# Access Compliance Report

## Public Rights-of-Way

### (Curb Ramps)

Intersection ID: 24936	Main Street: CARMEL_RD	Cross Street: CARMEL_FOREST_DR	Location: W
ADA ID: E785901D243D	Ramp Type: PerpDiag	Initial Pass/Fail: Fail	Overall Compliance: No
Severity Score: 22.5			
Codes/Mitigation Info/Possible Solution		Field Measurements/Component Compliance

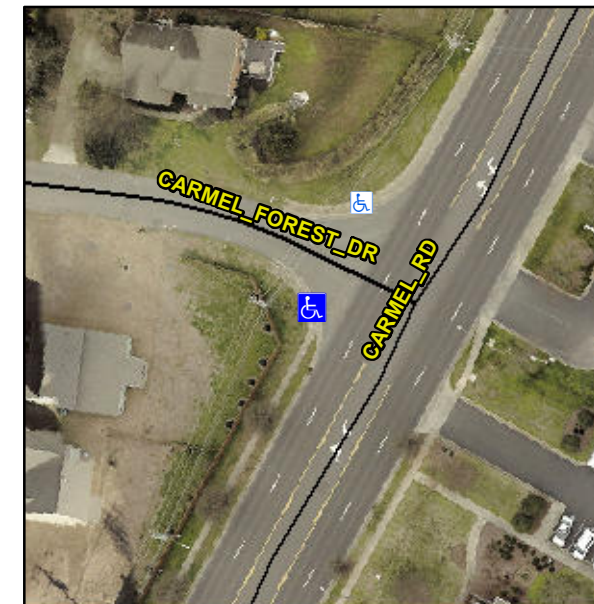
**Not Found, R304.5.1, R304.2.2, R304.5.3**

Compliance	Description	Data	Compliance	Description	Data
N/A	Ramp Length (in)	60.0	No	Ramp Slope (%)	8.9
No	Ramp Width (in)	43.0	No	Ramp XSlope (%)	3.0
N/A	Flare Type LT	N/A	N/A	Flare Type RT	N/A
N/A	Flare Slope LT (%)	N/A	N/A	Flare Slope RT (%)	N/A
N/A	Flare Traversable LT?	N/A	N/A	Flare Traversable RT?	N/A
N/A	Landing Length (in)	N/A	N/A	DWS Provided?	N/A
N/A	Landing Width (in)	N/A	N/A	DWS Contrast?	N/A
N/A	Landing Slope (%)	N/A	N/A	DWS Length (in)	N/A
N/A	Landing X Slope (%)	N/A	N/A	DWS Full Width?	N/A
N/A	Landing Curb? (Y/N)	N/A	N/A	DWS Offset (in)	N/A
N/A	Shared Landing?	N/A			
N/A	Gutter Ponding?	N/A	N/A	Gutter Slope (%)	N/A
N/A	Gutter Lip Ht (in)	N/A	N/A	Gutter X Slope (%)	N/A
N/A	Painted X Walk1?	No	N/A	Painted X Walk2?	No
	X Walk 1 Direction	To SE		X Walk 2 Direction	To NE
N/A	X Walk 1 Width (in)	N/A	N/A	X Walk 2 Width (in)	N/A
	X Walk 1 Slope (%)	3.4		X Walk 2 Slope (%)	2.6
	X Walk 1 X Slope (%)	2.8		X Walk 2 X Slope (%)	4.9

**Remove & Replace Curb Ramp With Two New Directional Ramps or Equivalent.**
